Information Item

Date: September 2, 2014

Subject: Colorado Esplanade - Revision of the Gateway Triangle Design

Figure 3

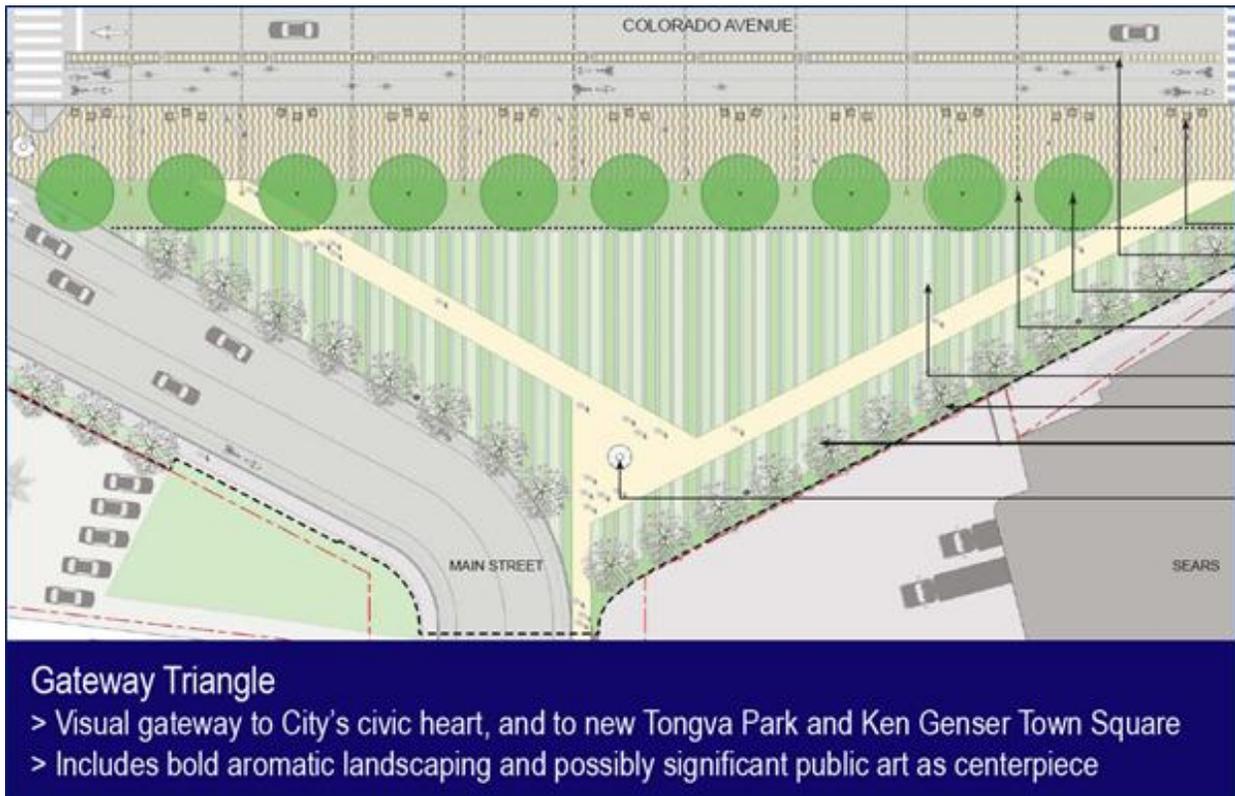
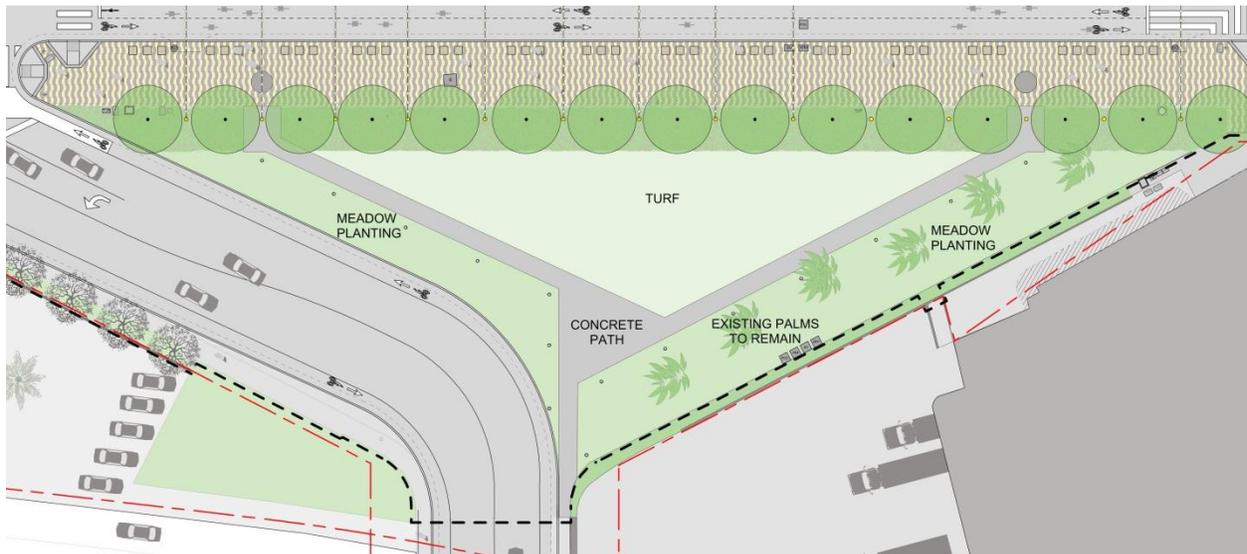
triangular landscaped area created by the realignment of Main Street to Second Street. The original design (presented at the May 14, 2013 Council meeting) is shown in Figure 1 and Figure 2.

The Gateway Triangle was discussed at length at the May 14, 2013 Council meeting and ultimately Council directed staff to come up with a more usable open space for this area. The original design consisted of the planting of shrubs that made the area unusable to people who wish to walk or sit in the area. Council requested more of an open space that people can utilize as if it were a small park.

Given Council's direction, staff and the design team developed a minimal design that keeps the walkway layout close to the original design, provides an open turf area, an open meadow grass area, keeps existing palm trees adjacent to Sears in place and provides for new meadow grass. This layout is included in the final construction documents (Figure 3).

for irrigation. Landscaping throughout the majority of the 5.5 acre project will utilize underground drip irrigation thus reducing treated urban runoff consumption. The areas within 5' of the pathways within the Gateway Triangle area will use drip irrigation as well. Areas more than 5' away from the path will utilize restricted spray irrigation of treated urban runoff. Of the 5.5 acre project only 0.23 acre will utilize spray irrigation. The existing gateway triangle area (before this construction) utilizes spray irrigation and is 0.38 acres, thus creating a 40% reduction in spray irrigated areas.
